Re: 412 Sparks Street CHIS Addendum #2

Ottawa Retirement Residence by Signature

Cultural Heritage Impact Statement:
Addendum to the March, 2019 Addendum
to the April 5, 2011 CHIS

Layby and landscape treatment on Sparks Street

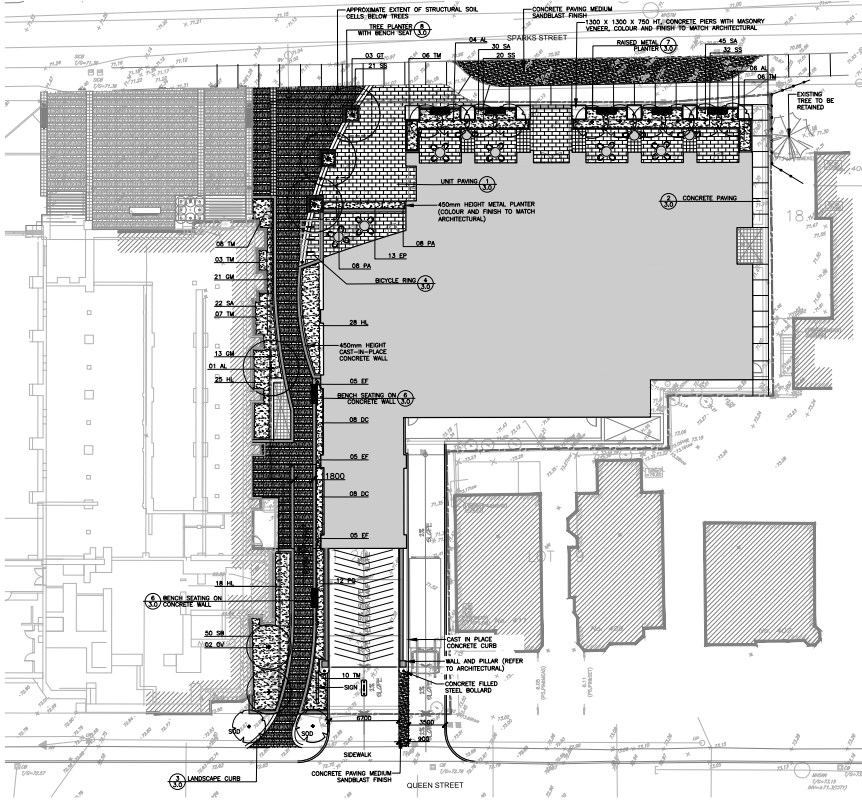
- Heritage staff continued to question the need for a layby, preferring to keep a wider sidewalk and have a loading bay created instead. They also wanted to see a continuous line of street trees along the sidewalk.

The consulting team is recommending that the layby is necessary in order to respond to the ongoing parking of tour buses on the north side of Sparks Street so that the retirement home's normal pick up and drop off actions, as well as emergency access, can be assured. The sidewalk will remain at the standard width and will curve around the layby, the surface of which is proposed to be textured concrete (with a rolled curb) to help it blend with the pedestrian realm. A row of street trees is proposed along the front of the retirement home, within the private realm: there will also be street trees alongside Sparks Street at the north end of Philosopher's Walk, flanking the parking garage pedestrian entrance. These landscape elements, combined with seating and decorative paving, are intended to enhance and extent the Cathedral forecourt and provide a coherent streetscape treatment along the south side of Sparks Street.
